INITIAL FIRE SAFETY INSPECTION REPORT

Yasin Knittex Ind. Ltd. (Extended building)

RSC ID: 24941

Fire Safety Inspection Report

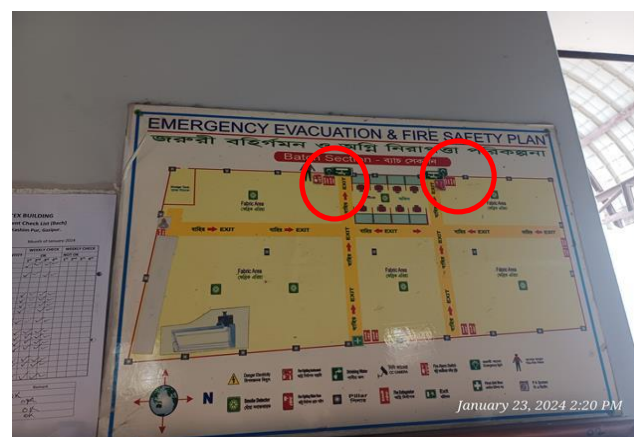
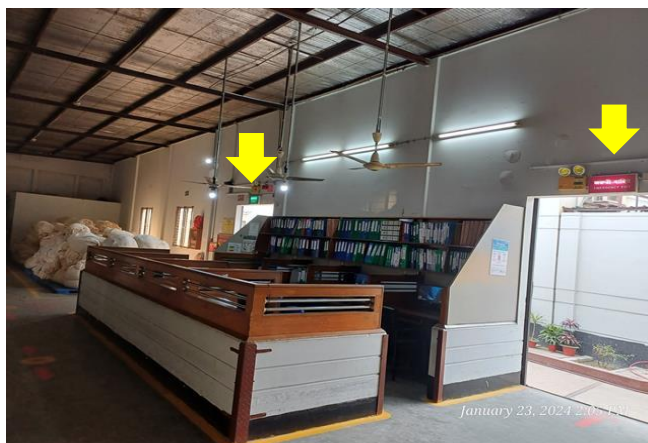
F-6	Means of Egress	Exits in the batch shed are not remotely located from each other. Location: Batch Shed	Modify exit arrangement or Provide additional exit(s) or Provide automatic sprinkler system throughout the building as per NFPA 13	Within 3 Months
-----	-----------------	---	---	-----------------

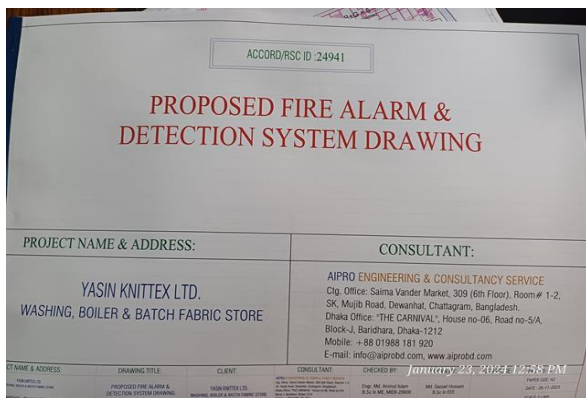
F-10	Fire Alarm & Detection system	Automatic fire alarm and detection system has been installed. FADS required a detailed review to confirm compliance with NFPA 72 and The RSC Technical Guidelines (Standard). Location: Batch shed, Washing & Boiler Shed	Submit the fire alarm system design to RSC for review. Once the design is reviewed, install and modify the fire detection and alarm system throughout the buildings in accordance with review comment, RSC Technical Guidelines (Standard) and NFPA 72. After installation the owner shall conduct internal testing and commissioning and then contact the RSC for witness of final acceptance testing. Also inspect, test and maintain the fire alarm system, and keep written records on-site, in accordance with Table-14.3.1 of NFPA 72.	Design Review within 2 months and installation/modification within 4 months
------	-------------------------------	--	---	--
